**Erf 942, 71 Dreyer Street, Stanford: Proposed departure.**

**ERF 942 STANFORD: 71 DREYER STREETREZONING AND DEPARTURE APPLICATION- RESPONSE TO OBJECTION**

**COMMENTS FROM THE ENGINEERING SERVICES DEPARTMENT FOR:  
APPLICATION FOR REZONING, DEPARTURE & AMENDMENT OF THE  
SPATIAL DEVELOPMENT FRAMEWORK: ERF 942, STANFORD (2803)**

**RE: PROPOSED REZONING OF ERF 942, STANFORD**

**Figure 1. Sketch illustrating the layout as suggested by the Stanford Heritage Committee**

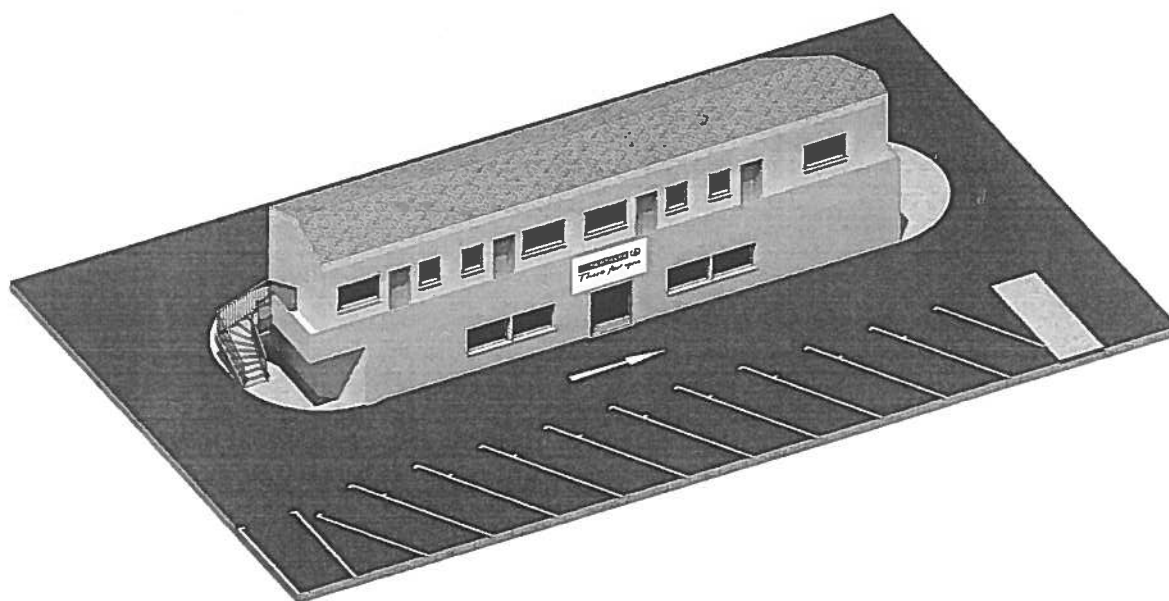
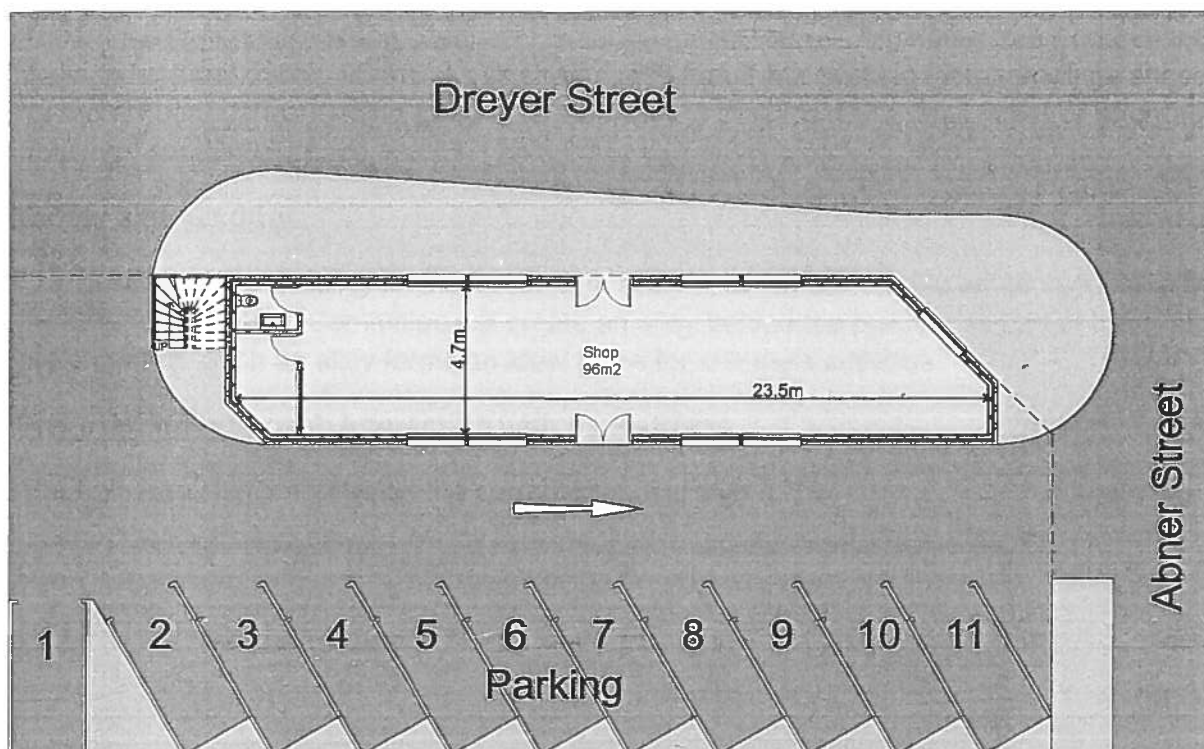
The various site plans and sketches included within the motivation show the proposed parking bays to be in front of the building, between it and the pavement/roadway. Current thinking suggests that retail environments should be connected to their customers as pedestrians, rather than as motorists. This philosophy would certainly apply in this case where the vast majority of this development's customer-base would be on foot.

For this reason we suggest that the building be moved forward and that the parking be at the rear.

In Figure 1 the building has been moved forward up to the street boundary and the parking provided at the back of the building as suggested by the Stanford Heritage Committee. In order to accommodate the parking and the vehicle flow the proposed building had to be narrowed from 32,5 m x 7,5 m to 23,5 m x 4,7 m. This implies a loss of 102 m<sup>2</sup> developable space per floor (i.e. total LOSS of 204 m<sup>2</sup> representing 53% of usable floor space).

The suggestion made by the Stanford Heritage Committee will contribute to an odd shaped building footprint of only 96 m<sup>2</sup>. As illustrated in Figure 1 the building footprint will be shaped by the erf boundaries leading to corners that are not practical for a retail outlet or affordable housing / residential space.

The position of the building on the street front and not at the back of the erf as suggested by the Stanford Heritage Committee will create an alley behind the building as part of the parking area. Such an alley forms an ideal place for criminals activities.
